AGENDA SECTION: CONTINUED - PUBLIC HEARINGS	ORIGINATING DEPT: PLANNING	ITEM NO. <b>E-2</b>
ITEM DESCRIPTION: General Development Plan(GDP) #219, to be known as Spring Brook Valley. The GDP includes a total of approximately 112 acres of land and proposes to develop the eastern 17.16 acres in the B-4 (General Commercial) district, with the western 94.14 acres developed in the R-1x (Mixed Single Family Extra) district. The Plan also identifies public and private roads, stormwater ponds, public parkland and accesses to the TH 63 Frontage Road. The property is located west of TH 63, south of TH 52 and Southtown Heights and north of 36 <sup>th</sup> ST. SW		PREPARED BY: Mitzi A. Baker, Senior Planner

To: Rochester Mayor and Common Council  
From: Phil Wheeler, AICP, Planning Director  
Date: January 16, 2004  
Re: Spring Brook Valley GDP

GENERAL DEVELOPMENT PLAN  
 Spring Brook Valley  
 12-22-03

**RE:** General Development Plan #219 to be known as Spring Brook Valley.

Figure 4: Half Closure

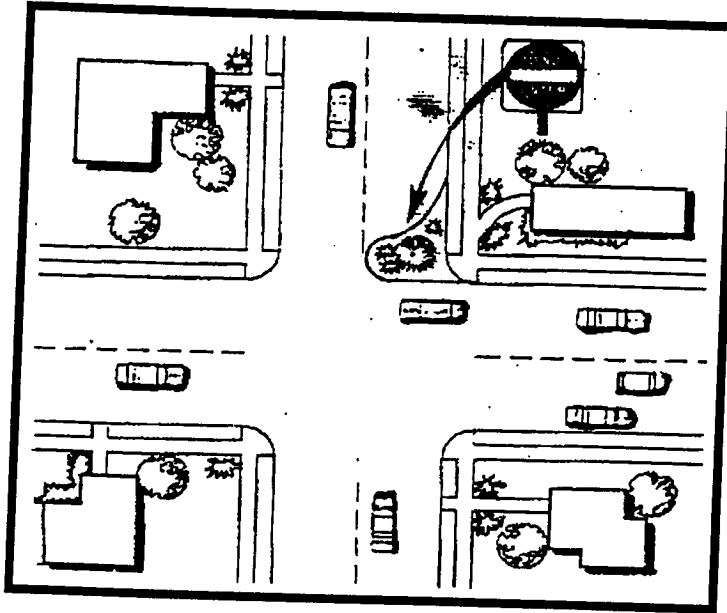
**Alternative 2:**

1. A second alternative is to consider some traffic calming options on the extension of Willow Ridge Drive. One option as illustrated in figure 4 would permits only inbound/northbound traffic.
